DOCKETED	
Docket Number:	25-OPT-01
Project Title:	Viracocha Hill Battery Energy Storage System Project
TN #:	267238
Document Title:	Determination of Incomplete Application and Request for Information for the Viracocha Hill Battery Energy Storage System Project
Description:	N/A
Filer:	Marichka Haws
Organization:	California Energy Commission
Submitter Role:	Commission Staff
Submission Date:	11/14/2025 1:47:01 PM
Docketed Date:	11/14/2025

Determination of Incomplete Application and Request for Information for the Viracocha Hill Battery Energy Storage System Project (25-OPT-01)

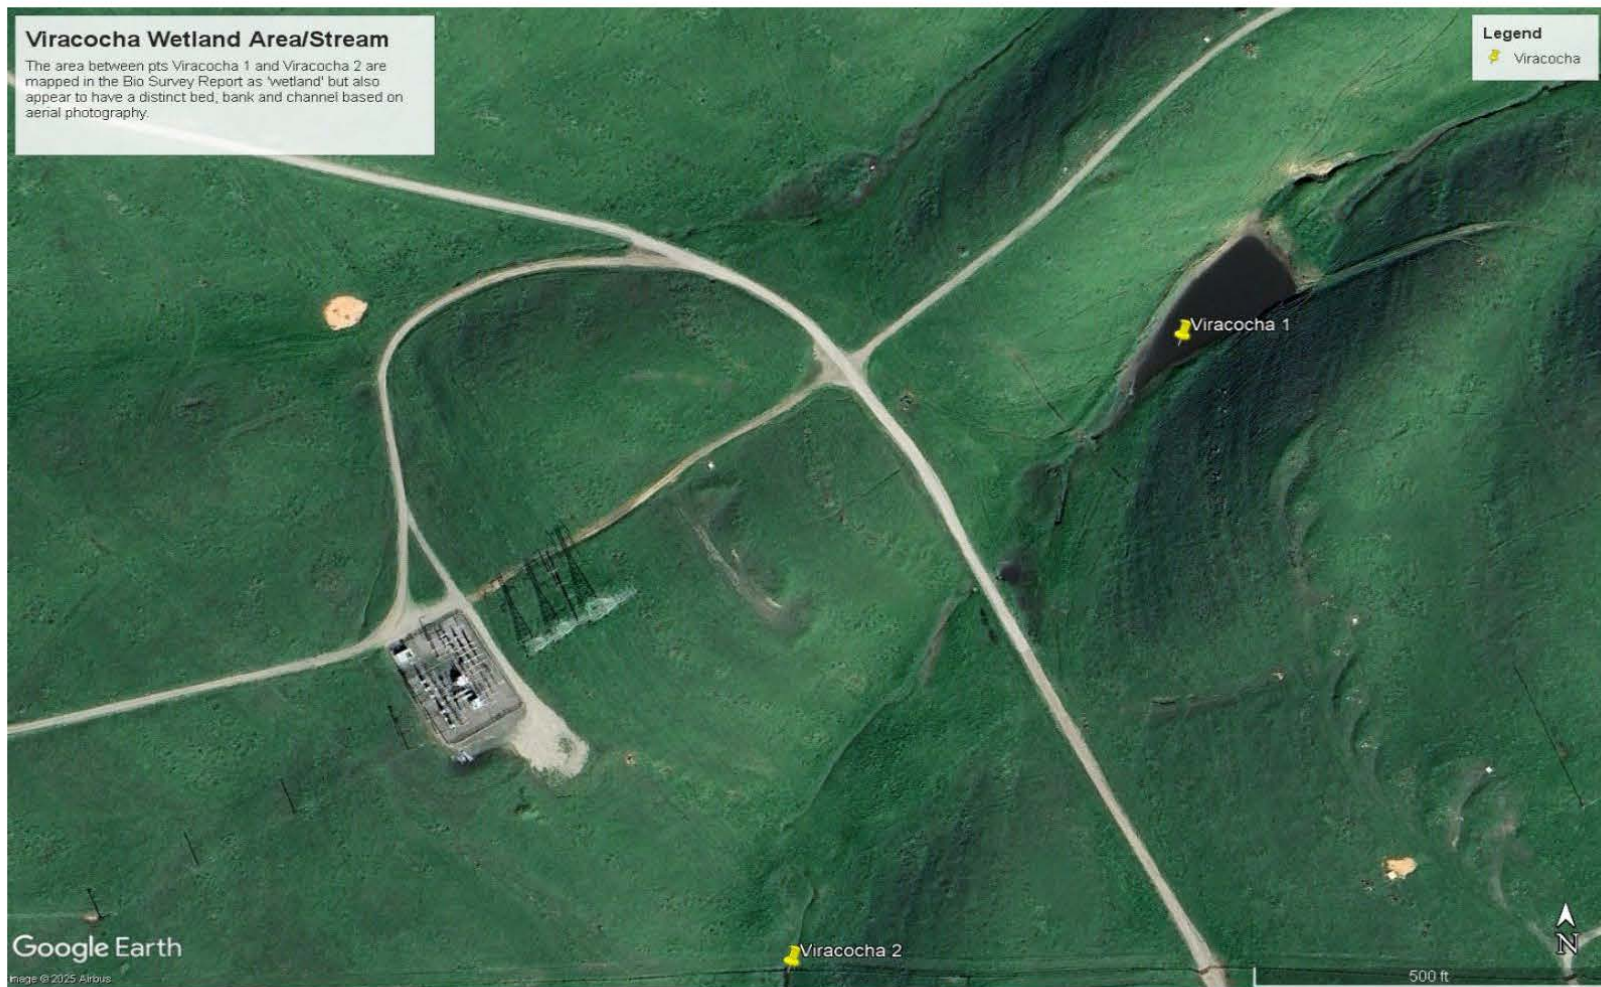
Aquatic Resources Delineation. California Code of Regulations for Opt-in Projects, title 20, section 1877 (a), for Applicants seeking a lake and streambed alteration authorization under Fish and Game Code section 1602, requires the application include information required in California Fish and Game Code section 1602(a)(1)(A)-(F). Sections 3.5

to 3.8 of the CBSR discusses the aquatic resources delineation, but does not include ephemeral streams as an example of an aquatic feature. Based on CEC staff's review of aerial photography – in coordination with CDFW –, features within the project site, particularly in the southeast area mapped as a wetland in Figure 3-3 of the Biological Resources Survey Report, may function as ephemeral streams (see photo below). If ephemeral streams are present, activities within or near them may be subject to notification requirements under California Fish and Game Code, section 1602.
